# UNITED STATES PATENT AND TRADEMARK OFFICE

APPLICATION NO.	FILING DATE	FIRST NAMED INVENTOR	ATTORNEY DOCKET NO.	CONFIRMATION NO.
09/683,482	01/07/2002	Jia-Fam Wong	ADTP0028USA	2814

# Office Action Summary

## DETAILED ACTION

FIG. 9

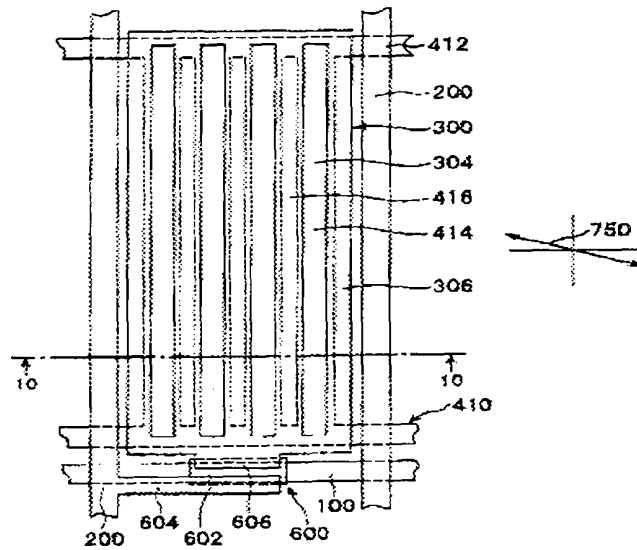
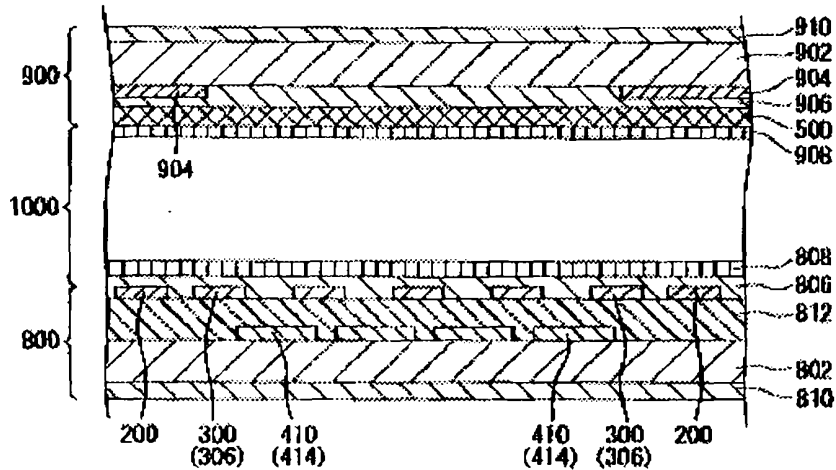
As to claims 1, 3 and 4, Matsuyama discloses in Figures 9 and 10, third embodiment (col. 21, line 36 through col. 22, line 55), a liquid crystal display (LCD) comprising: a first substrate, 900, comprising a first surface; a second substrate, 800, comprising a second surface, the second surface being in parallel with and opposite to the first surface of the first substrate, and a pixel area being defined on the second surface; a second common electrode, 500 (Applicant's first electrode), positioned on the first surface of the first substrate; a first common electrode, 410 (Applicant's second electrode), disposed above the pixel region of the second substrate, the second electrode having side opening portions, 416 (Applicant's first slit) elongated along a first

direction; an isolation layer, 812, disposed on the surface of the second substrate to cover the second electrode; a pixel electrode, 300 (Applicant's third electrode), disposed on the isolation layer and within the pixel region, opening portions, 304 (Applicant's second slit), being defined on the third electrode and along the first direction, the first and second slits being interlaced (per Figures 9 and 10); and a plurality of anisotropic liquid crystal molecules with negative dielectric constant (Abstract) positioned between the first electrode and the third electrode, the longitudinal axis of the liquid crystal molecules being positioned along a second direction horizontally (Figure 3 and col. 21, lines 42-45), and a first angle being formed between the first direction and the second direction; wherein a biased electric field is formed as a voltage is applied between the first electrode and the second electrode, such that (a) a first horizontal biased electric field is formed in the neighborhood of the second slit (Figure 4), the first horizontal biased electric field is perpendicular to the first direction, and the liquid crystal molecules are rotated to make the longitudinal axis of the liquid crystal molecules in the neighborhood of the second slit being in parallel to the first direction, (b) the longitudinal axis of the liquid crystal molecules in the neighborhood of the first electrode maintain along the second direction because no horizontal biased electrical field is formed near the first electrode, and (c) the liquid crystal molecules between the first electrode and the second slit of the third electrode gradually rotate from the second direction to the first direction,

wherein the second electrode, 410, is a transparent common electrode (Applicant's pixel electrode) (col. 15, lines 14-17 and col. 21, lines 42-45) and wherein the third electrode, 300, is a transparent pixel electrode (Applicant's second common electrode).

However, Matsuyama does not explicitly disclose a display wherein the second electrode, 410, is a pixel electrode and wherein the third electrode, 300, is a lower common electrode.
